NOAA Technical Note NCDC No. USCRN-04-06

USCRN Temperature Aspirated Shield Modifications

October 2004

Figure 6: Aspirated shield fans before (left) modifying by enlarging the mounting holes, and after the modification (right). The mounting holes are enlarged from the original 0.17” to be 0.40” diameter.

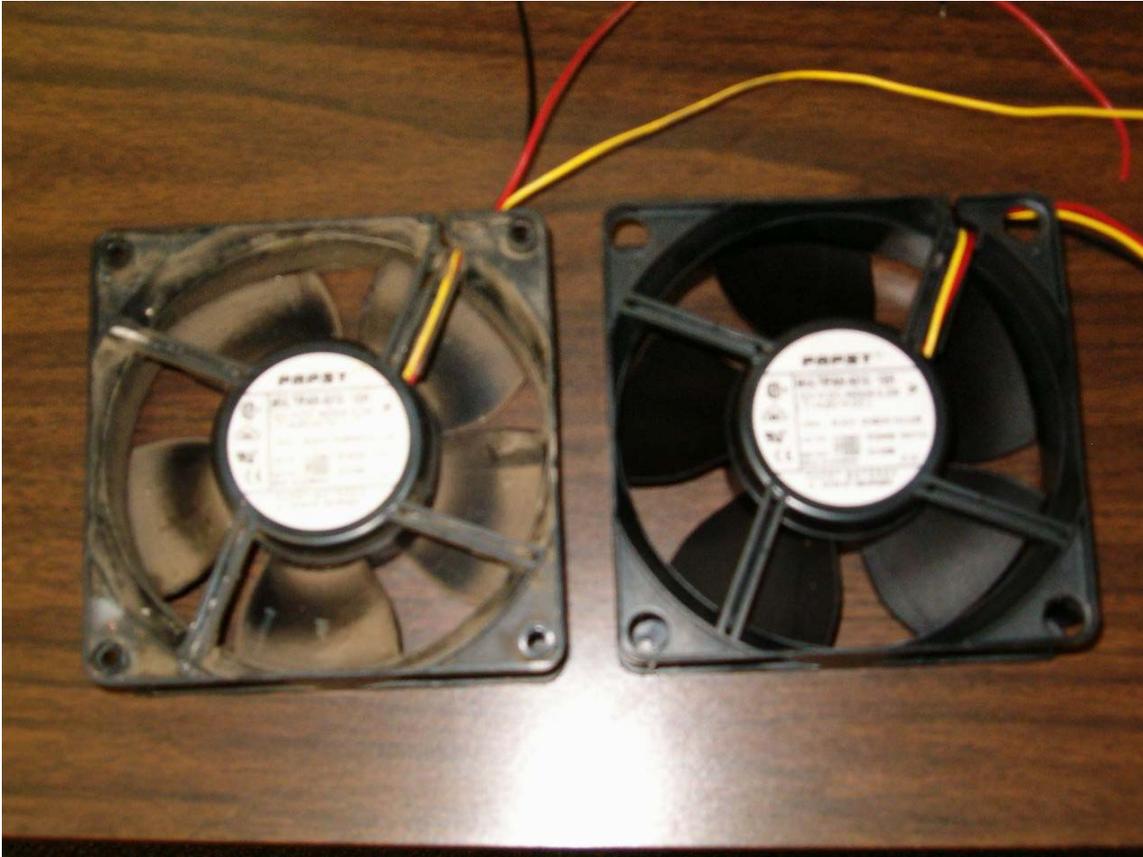
The ATDD modification consists of removing the fan and securing the remaining assembly with the original nuts. The mounting holes on the fan are then bored out from their original 0.17" inch diameter to a diameter of 0.40". This allows the fan to be placed into the fan chamber such that the nuts on the mounting bolts fit within the enlarged holes. A second set of nuts is then applied on all four bolts on the outside holes on the fan, which have been left at their original size. This allows the fan to be removed without disassembling the entire shield apparatus.

Figure 6 shows, on the left, the fan assembly prior to enlarging the top mounting holes. On the right the holes have been enlarged. The enlarged holes fit over the added fastener, as seen in Figure 5, and allow the fan to fit snugly at the top of the fan chamber.
